**RE: MassDEP Wetlands File No. 246-0785 – Information Request #4
8 View Avenue, Northampton, MA**

This memorandum is in response to your additional information request #4 received in an email dated June 18, 2025. The following memo addresses the four items requested.

ROOF DRAIN DETAIL PLAN

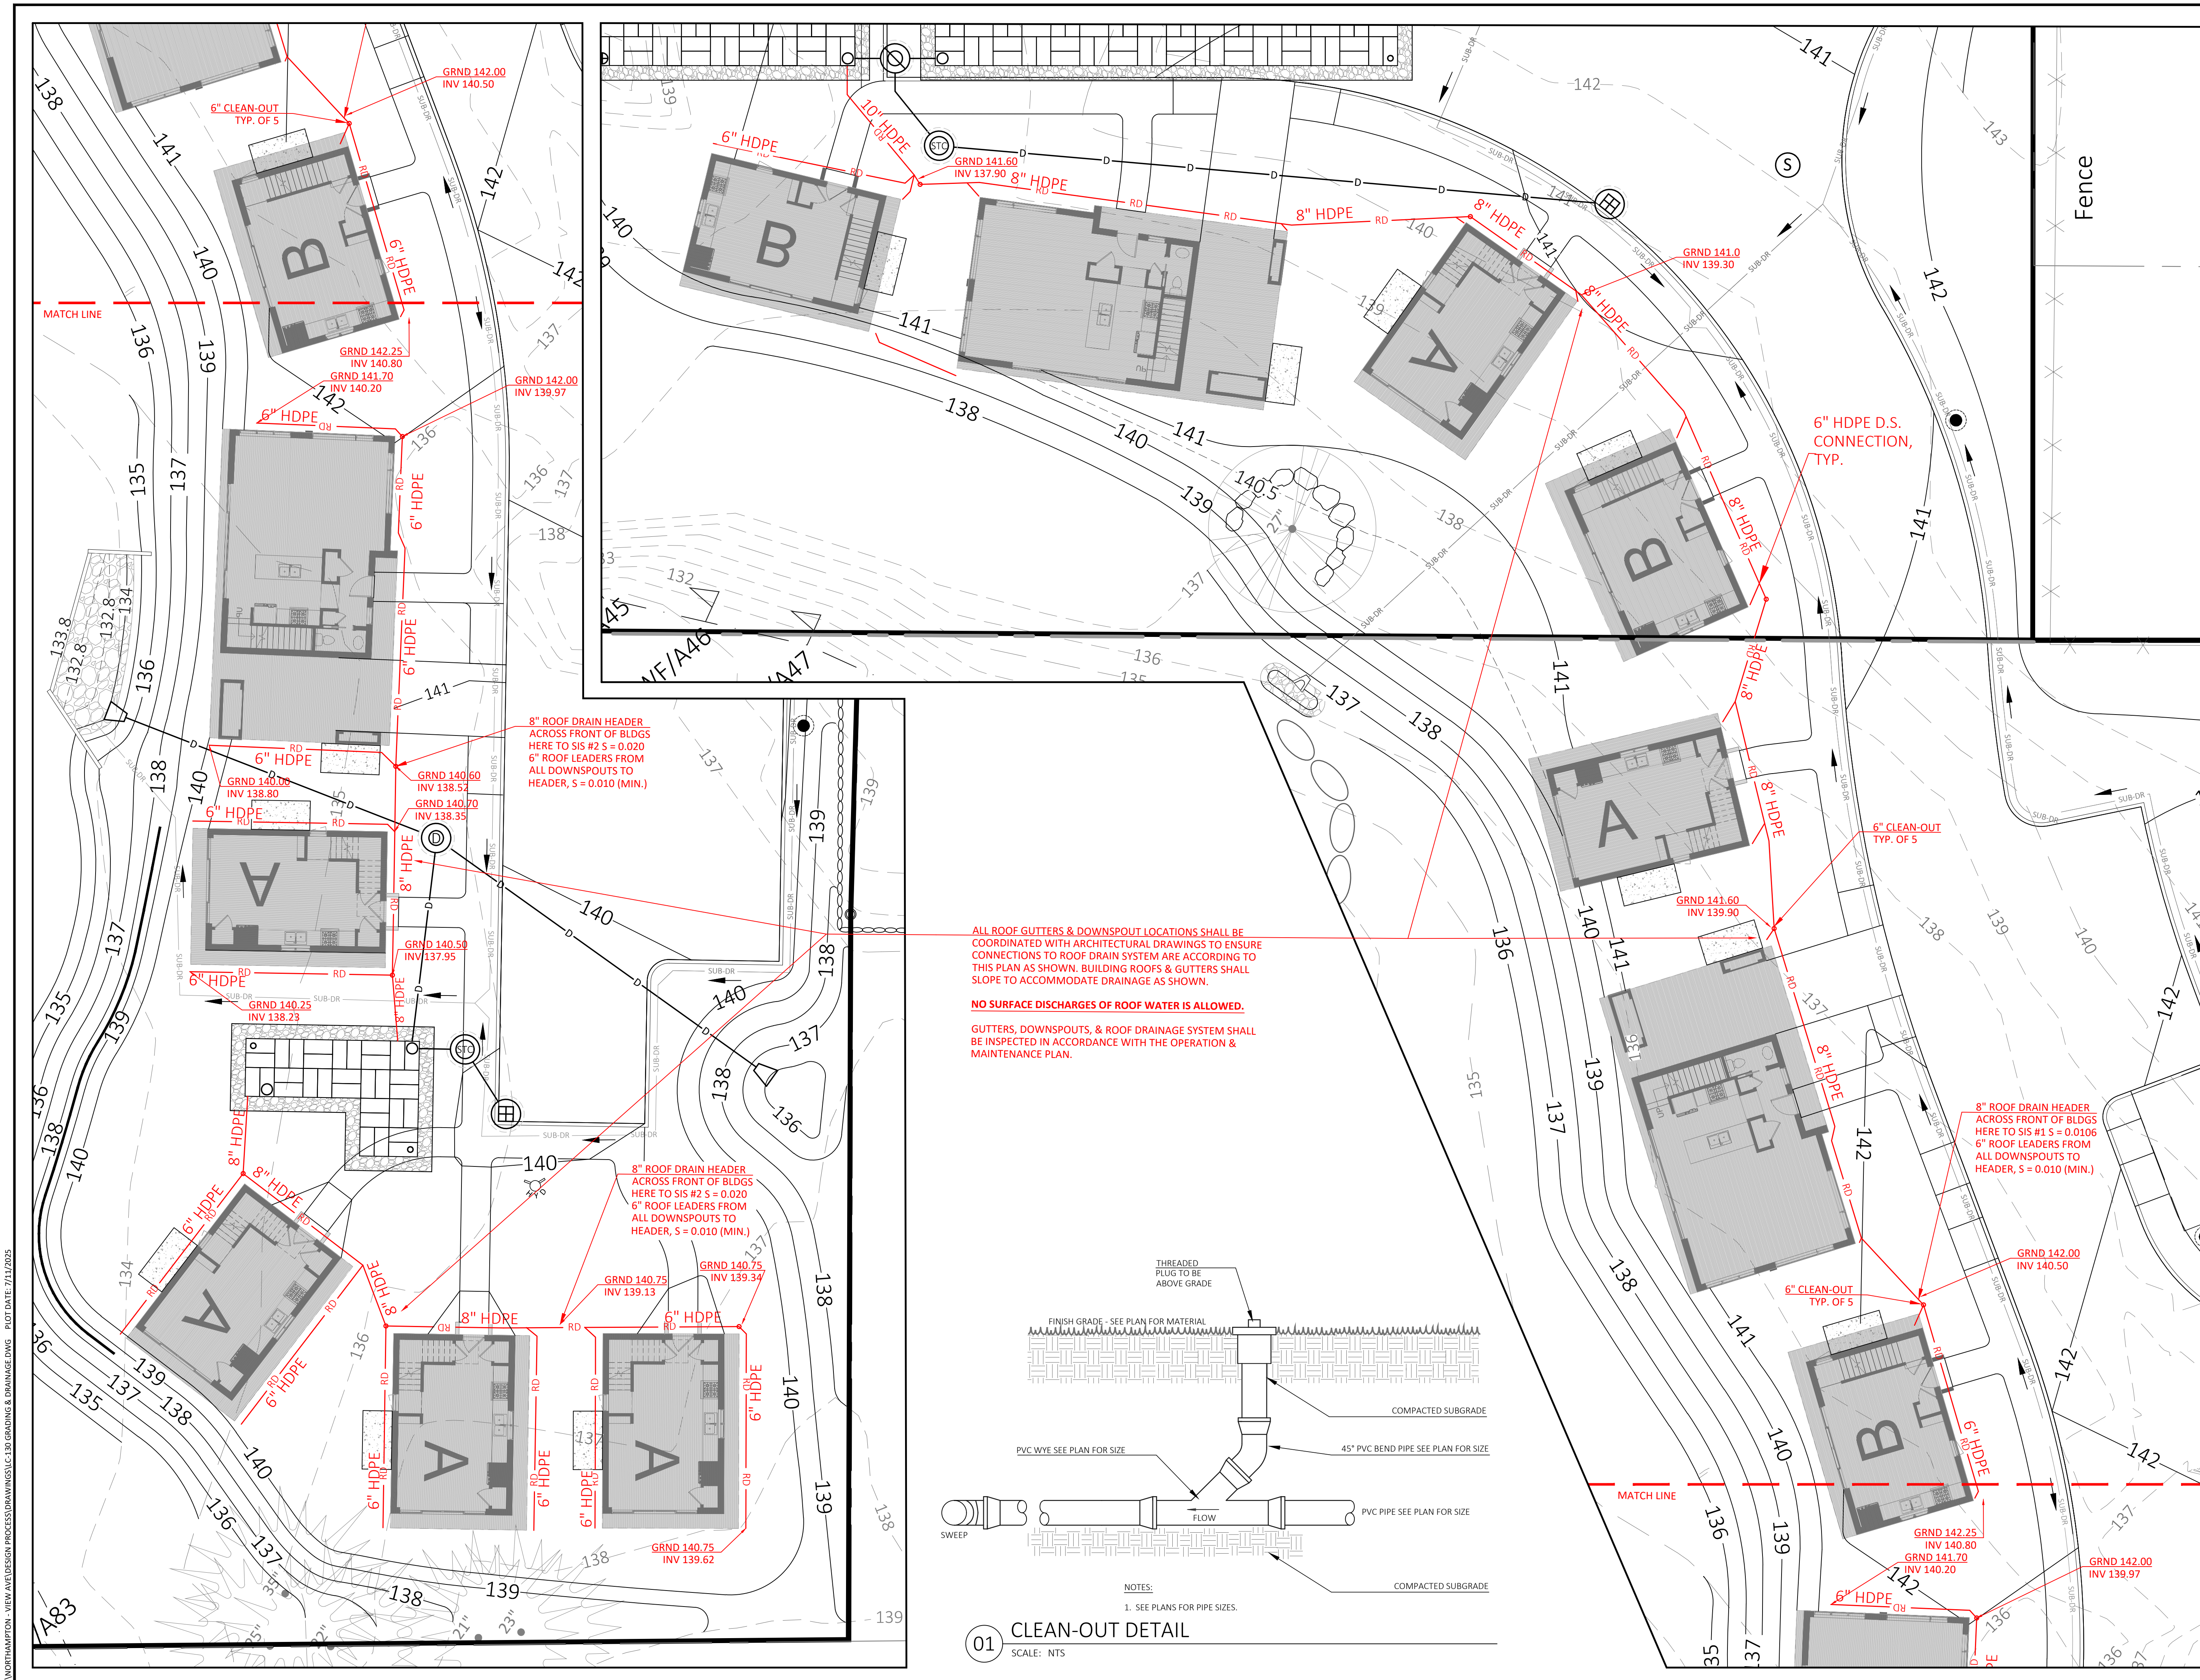
- 2. A detail sheet of the roof drain collection system, including documentation that there is appropriate ground cover, slopes, cleanouts and inspection ports, protections against damage, and plans for long-term maintenance.**

Sheet LC-132 is enclosed which updates and clarifies the proposed roof drainage collection system. This sheet includes a note stating requirements of the architectural design to incorporate roof slope directions and design of gutters and downspouts to the piped drainage system, so these requirements are included on the plan of record.

<p>Sovereign Builders 8 View Avenue Northampton, MA</p>		<p>FIG. 1 07/11/2025</p>	
		<p>Berkshire Design Group 4 Allen Place Northampton, MA 01060 (413) 582-7000 www.berkshiredesign.com</p>	
<p>Estimated Groundwater Elevations</p>

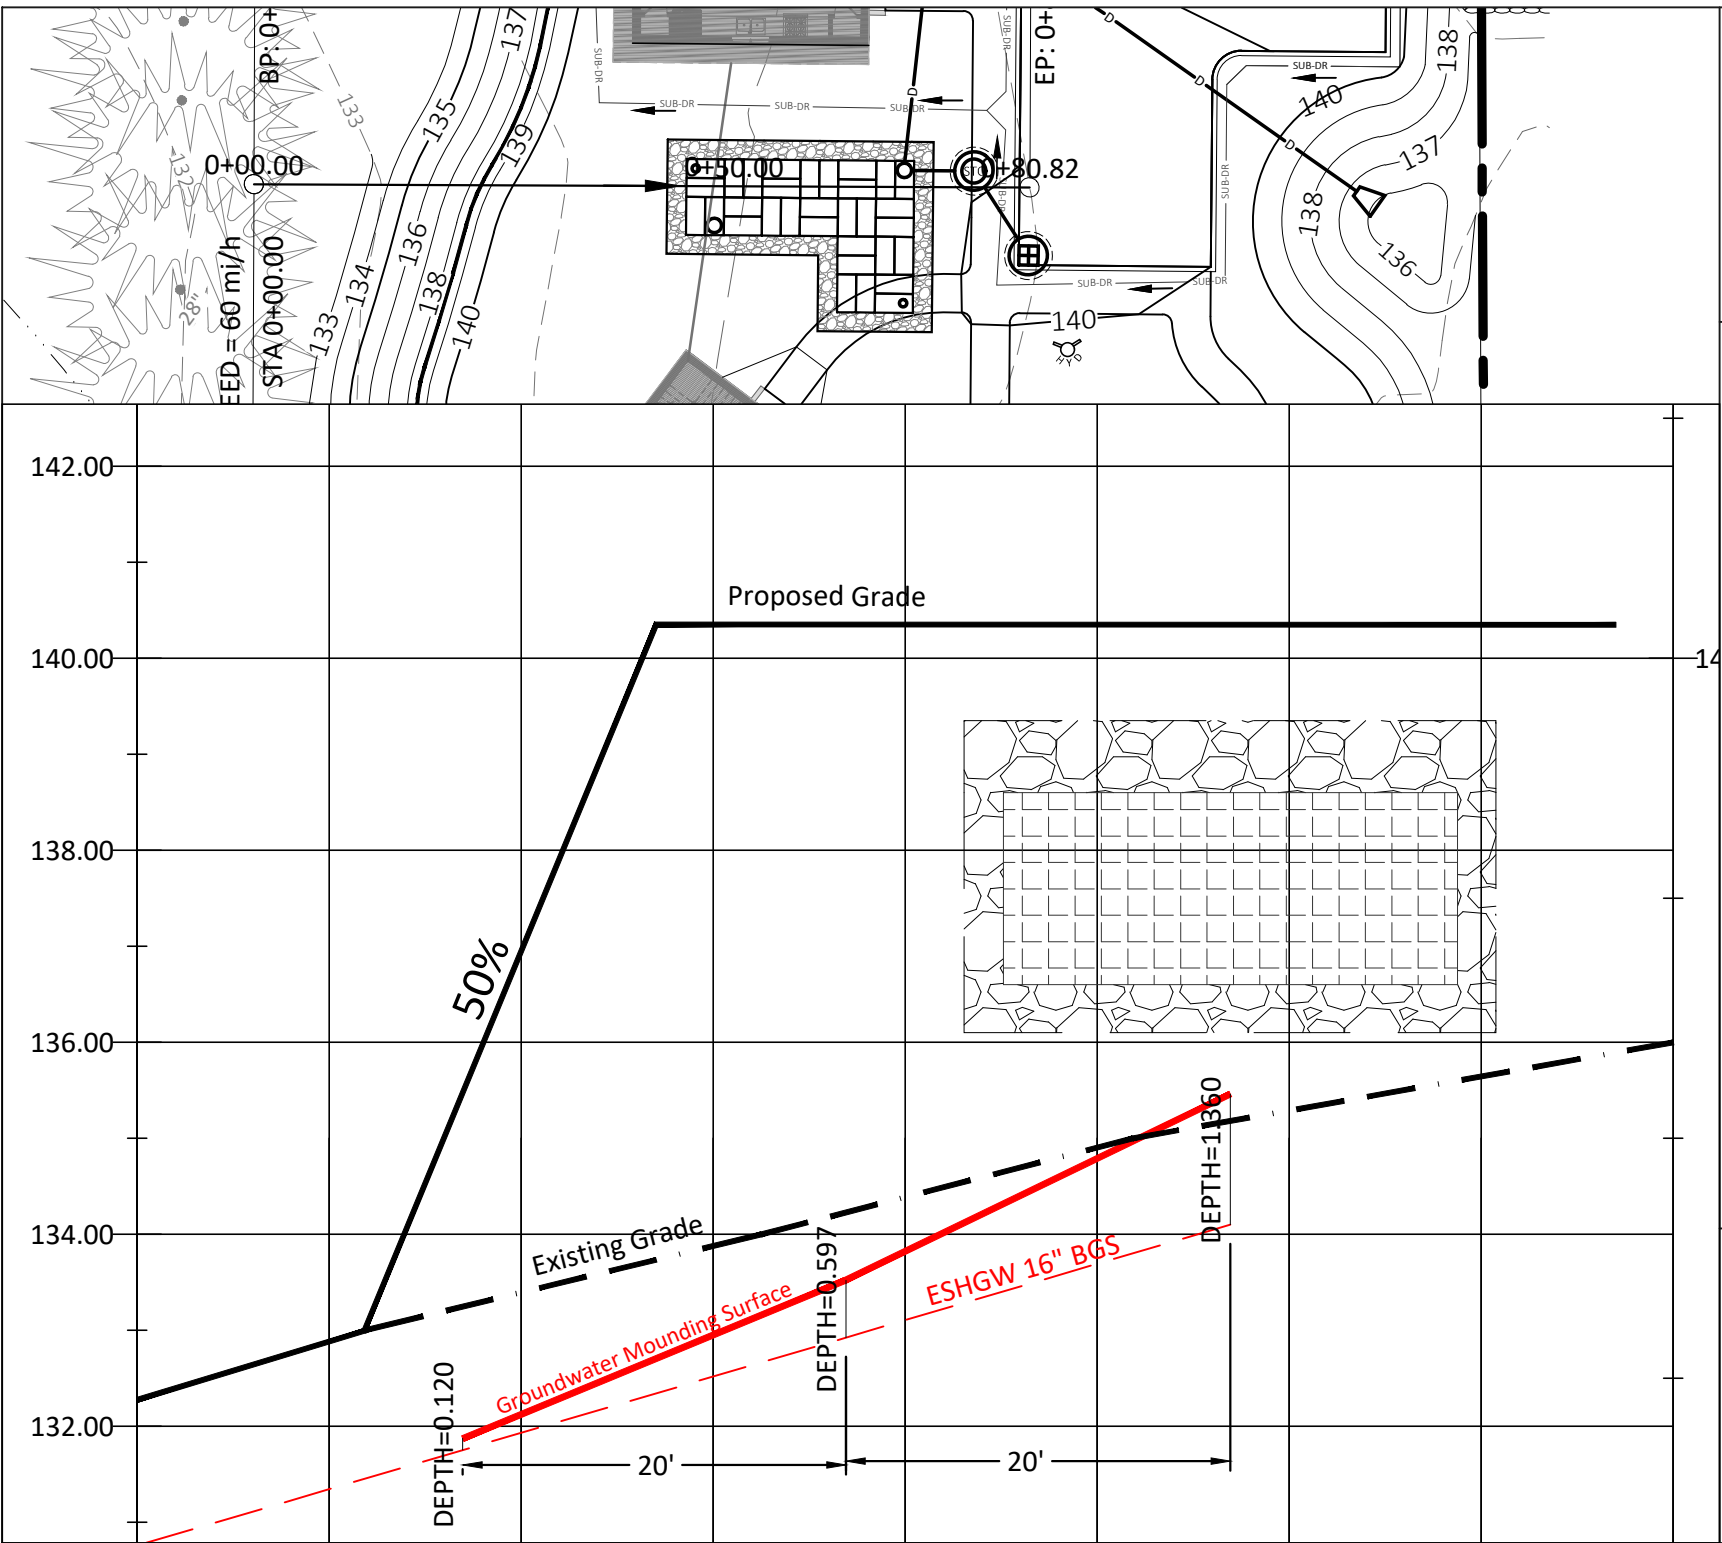
- 1. The plans of record must include documentation of how SIS#2 meets the requirements of the Massachusetts Stormwater Standards. Specifically, the groundwater mounding analysis method shall account for the nearby vertical impervious barrier, be redesigned to remove the need for the barrier, or another alternative method of accurately completing the groundwater mounding analysis, considering the assumptions of the method. The mounding analysis shall be accompanied by a written narrative prepared by a qualified hydrogeologist or geotechnical engineer that explains the rationale for determining input values and analysis outputs.**

The infiltration basin has been redesigned to remove the impermeable barrier. The guideline in the Massachusetts Stormwater Handbook recommends that a setback for infiltration basins be maintained at 50 feet away from slopes greater than 15% (Volume 2, Chapter 2, Page 88). This general guideline is to prevent the groundwater breaking out above the finished grade at any location. Since we have a site-specific mounding analysis that was conducted and several test pits nearby, an analysis was conducted to determine the site-specific groundwater breakout elevations. The ESHGW elevation at TP-3 at the location of the basin and TP-1, 16 feet southwest of the basin both have depth to groundwater of 16 inches below existing grade. The mounding analysis indicates that the maximum groundwater depth above the ESHGW is at 1.36 feet in the center of the basin and is 0.122 at 40 feet from the center of the basin. Enclosed with this response is a cross-section of the proposed SIS #2, existing grades, proposed finished grades, the ESHGW surface and the height of mounding about the ESHGW surface. This analysis determines that there would not be breakout at the slope.
